PRODUCT UPDATE: Changes to Color coding, Die packages and Accusizer labels.

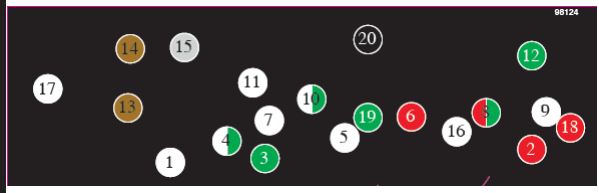
- The color coding of Huth segment sets has changed to correlate with HUTH bending dies.
 - Segments are also now painted on the face in order that they can be identified when installed on the arbors.
 - The chart below shows the previous 'OLD' color vs. the 'NEW' color.

Segment Set	Colors		Arbor/Tip	
	OLD	NEW	OLD	NEW
472/473	Yellow	Red	508 & 498	572
474	Red	White	508 & 499	573
475	Black	Green		
476	Green	Gold		
477	N/A	Silver		
478	N/A	Black
